STATE OF WASHINGTON
DEPARTMENT OF ECOLOGY

M E M O R A N D U M
October 13, 1983

To: Roger Ray
From: Bill Yake *BY*
Subject: Chewelah Class II Inspection and Receiving Water Report

Figure 1. Colville WTP and sample locations.

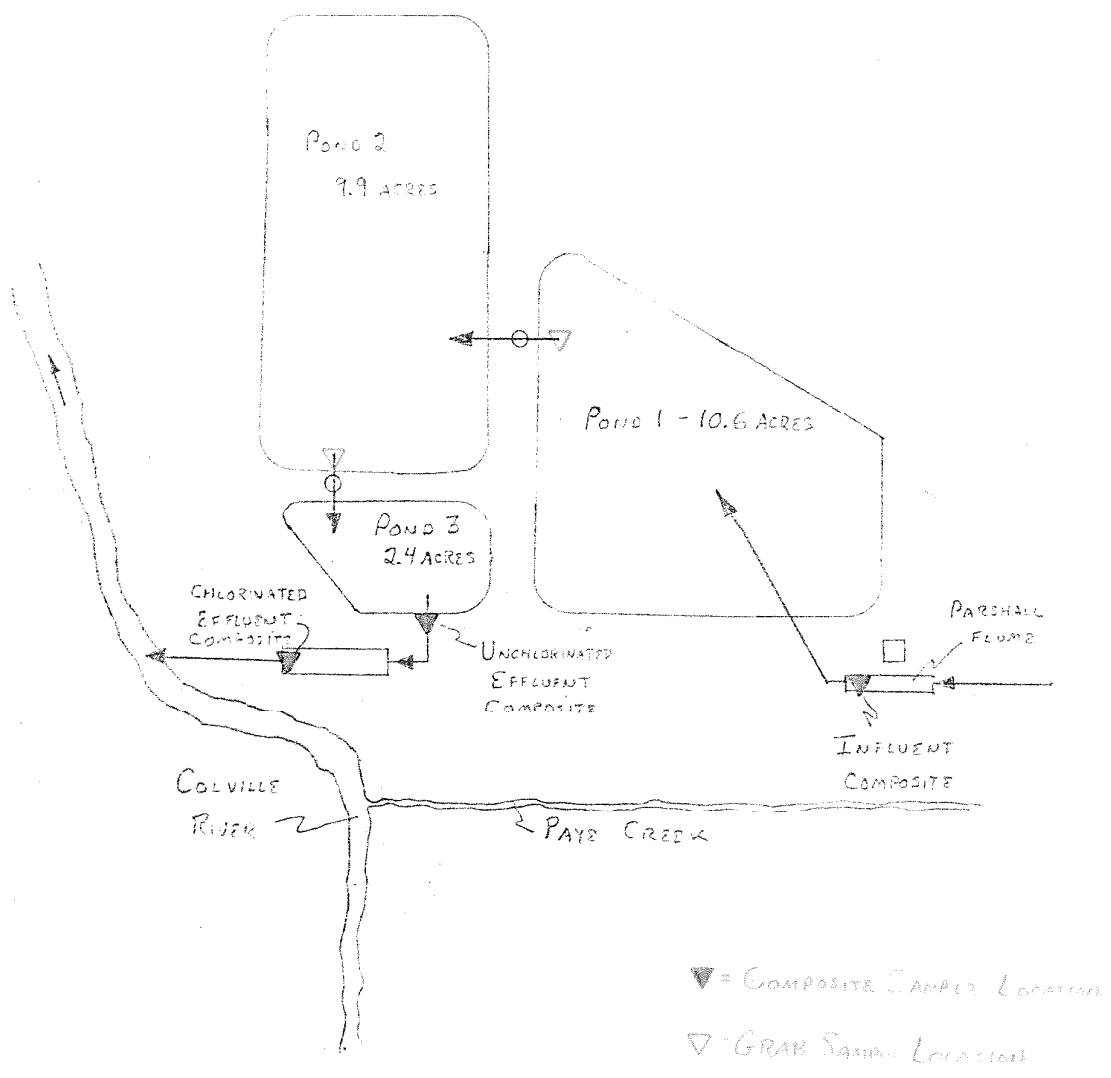
Flow Measurement: At the time of the inspection, plant operators were measuring plant flows at a rectangular weir at the discharge end of the chlorine contact tank. There are several problems with these flow measurements:

1. The weir is quite long (about 4-1/2 feet) and thus water depth (head) measurements are small; about 1-3/8 inches during the inspection. Therefore, small errors in head measurement may lead to fairly substantial errors in flow estimation.

2. Head measurements were being made directly above the weir rather than a foot or so upstream. This leads to an under-estimation of flow.
3. Instantaneous flow measurements do not provide an accurate 24-hour total flow.

1. Chewelah should install and accurately calibrate a continuous flow meter with script chart recorder and flow totalizer. This meter should be installed using the Parshall flume as a primary flow-measuring device.
2. Flows reported on the DMRs should be totalized flows for 24-hour periods.
3. Until this flow meter is installed, flow measurements at the effluent weir could continue; however, care should be taken to obtain precise head measurements and these measurements should be made at least eight inches upstream from the weir.

2. Flow-monitoring procedures at the Chewelah facility should be improved:
 - a. An accurate flow-measuring device should be installed at the influent Parshall flume. This device should have both script chart and totalizer capabilities.

- b. Flows reported on the DMRs should be totalized flows for 24-hour periods.
 - c. Until this flow meter is installed, flow measurements at the effluent weir may continue. However, these flows should be calculated from precise head measurements obtained at least eight inches upstream from the weir.

Figure 2. Chewelah WTP influent flow recorder.

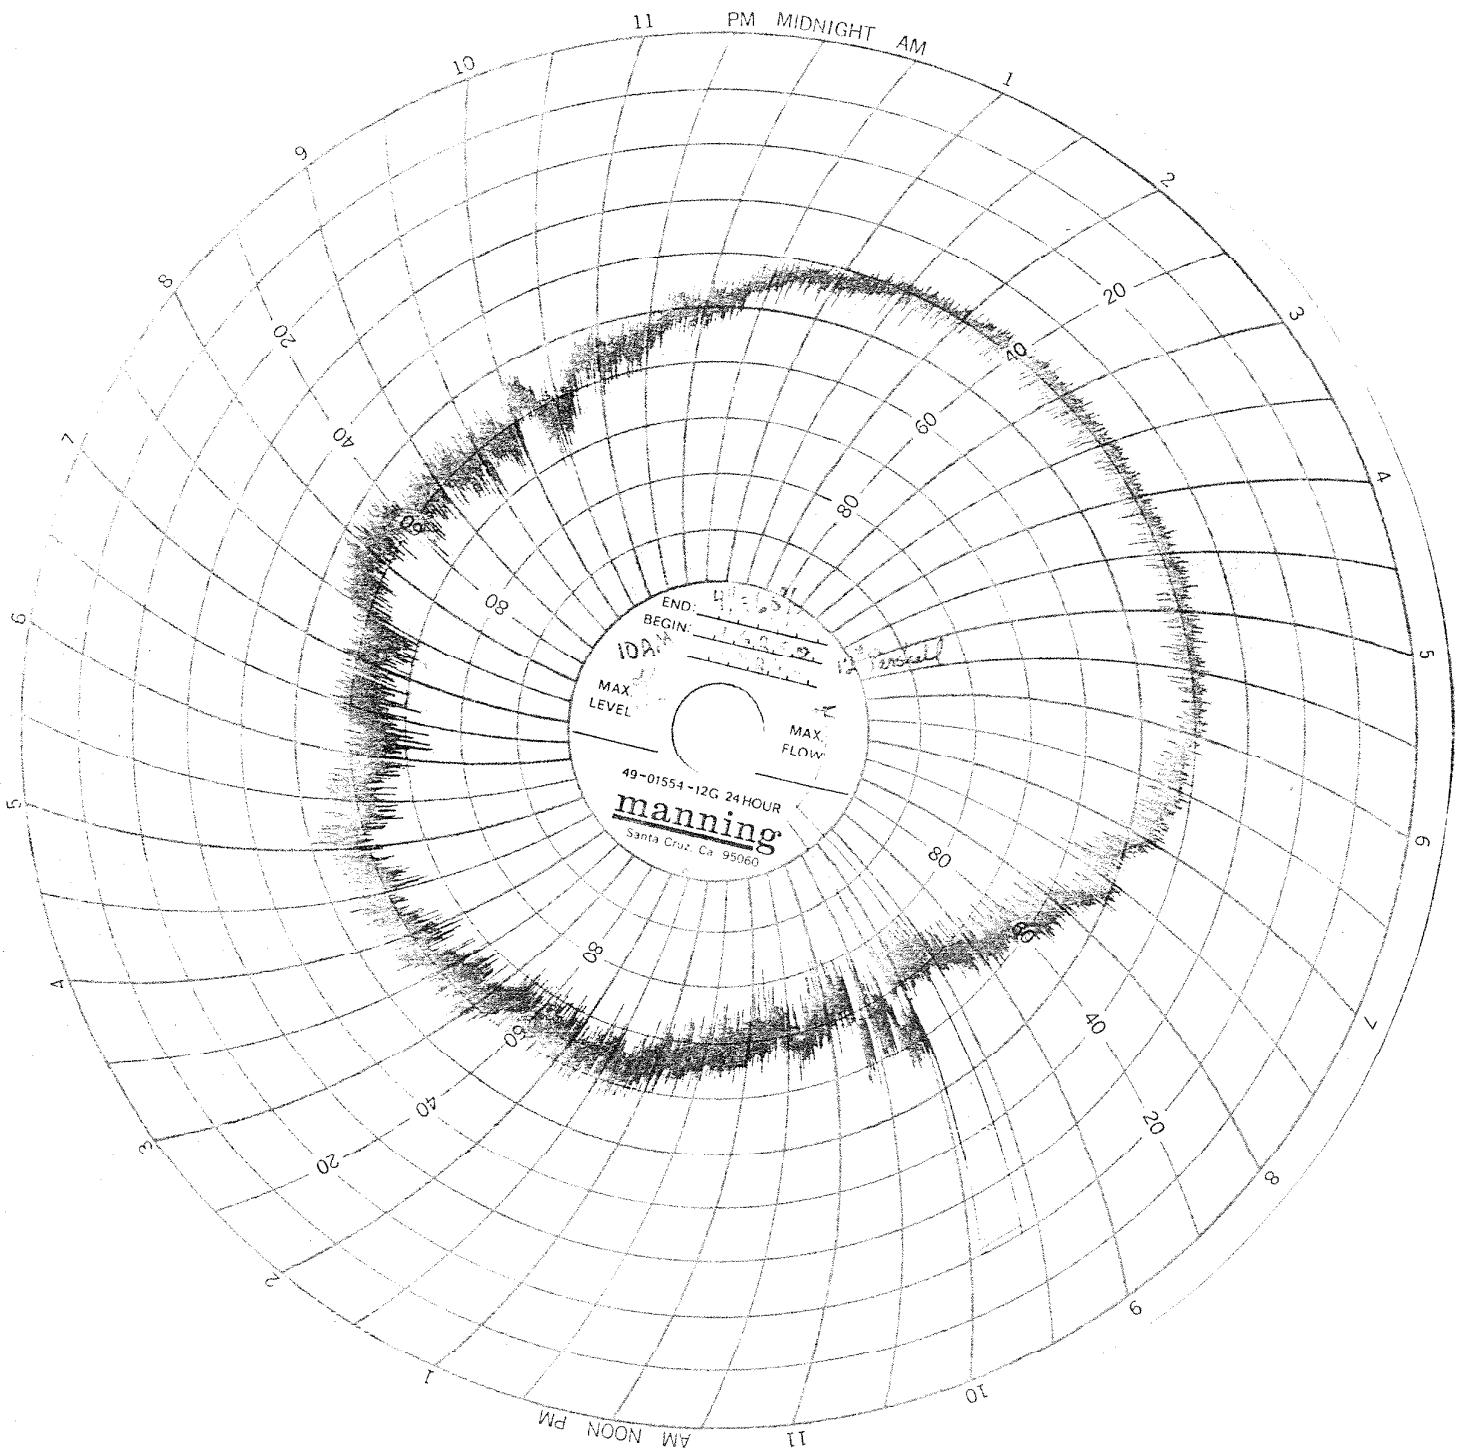
Other than chlorine residual (see Review of Analytical Procedures), the only parameter approaching permit or order limits was flow with a measured 24-hour flow of 0.41 MGD vs. a monthly average limit of 0.45 MGD. Based on Figure 2 (flow meter script chart), the overnight flow rate was about 0.2 MGD. This should be approximately equivalent to infiltration/inflow (I/I). Although the flows measured at the plant and subsequently reported on the DMRs are somewhat questionable and probably underestimate plant flow (see Review of Flow-Measuring Procedures), excessive flows at the Chewelah plant appear to be a chronic problem. This problem appears to be especially severe during the late winter and early spring when DMRs report monthly average flows approaching 0.9 MGD. These flows are four to five times higher than the 0.2 MGD one would expect based on the standard estimate of 100 gallons/capita/day for a service population of 2,000.

The most obvious implication of this excess flow is that it drastically reduces the detention time of the wastewater in the lagoon system. Because the high flows to the plant occur when the temperature of wastewaters in the lagoon is low, treatment efficiency would be expected to deteriorate seriously during the winter and spring. Although inadequate sampling procedures at the Chewelah plant cast particular doubt on the representativeness of influent BOD and suspended solids results, DMRs appear to show very weak influent strength and poor removal efficiencies (less than 50 percent) during the months of January to April.
